SOLICITATION AMENDMENT MODIFICATION DE L'INVITATION

Title - Sujet CCG Heating Line Replacement	
Solicitation No. - N° de l'invitation EB144-210024/A	Amendment No. - N° modif. 002
Client Reference No. - N° de référence du client EB144-21-0024	Date 2020-05-21
GETS Reference No. - N° de référence de SEAG PW-SPWA-405-5997	
File No. - N° de dossier PWA-0-84004 (405)	CCC No./N° CCC - FMS No./N° VME
Solicitation Closes - L'invitation prend fin at - à 02:00 PM on - le 2020-05-28	Time Zone Fuseau horaire Atlantic Daylight Saving Time ADT
F.O.B. - F.A.B. Plant-Usine: <input type="checkbox"/> Destination: <input checked="" type="checkbox"/> Other-Autre: <input type="checkbox"/>	
Address Enquiries to: - Adresser toutes questions à: Kendell (PWA), Byron	Buyer Id - Id de l'acheteur pwa405
Telephone No. - N° de téléphone (902) 497-5345 ()	FAX No. - N° de FAX (902) 496-5016
Destination - of Goods, Services, and Construction: Destination - des biens, services et construction:

La modification 002 vise à indiquer ce qui suit:

Image 2A

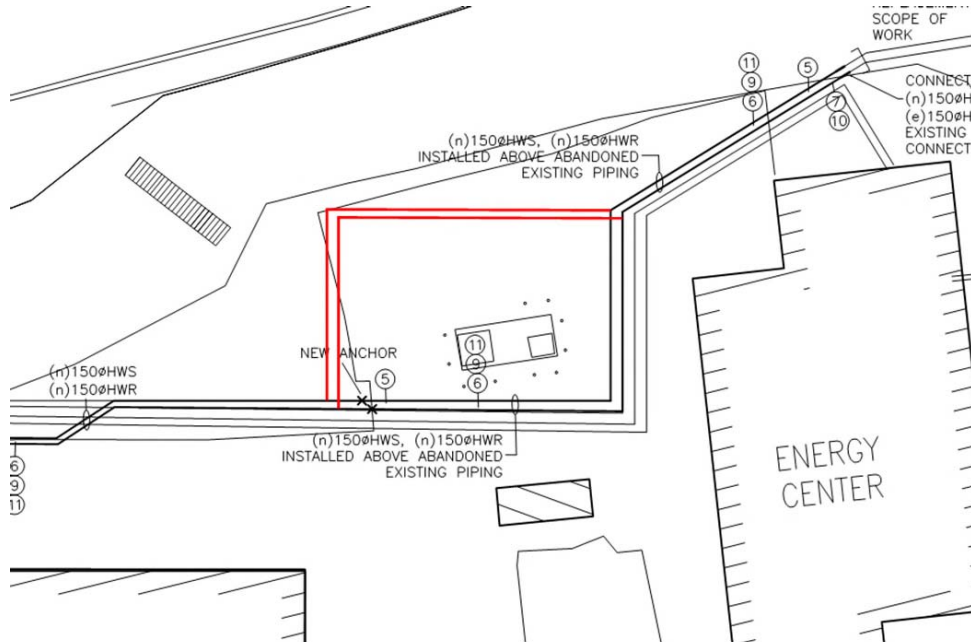
Question 4: Is it possible to reroute the new mechanical conduits so as not to cross the power conduits? Refer to **Images 2A** and **2B** below.

Réponse 4: Yes, that approach is fine. Although note all requirements around tie-ins, pipe removals/abandonment, etc. for where the routing of the new piping diverges from the routing of the existing. All of these will apply for the routing adjustment.
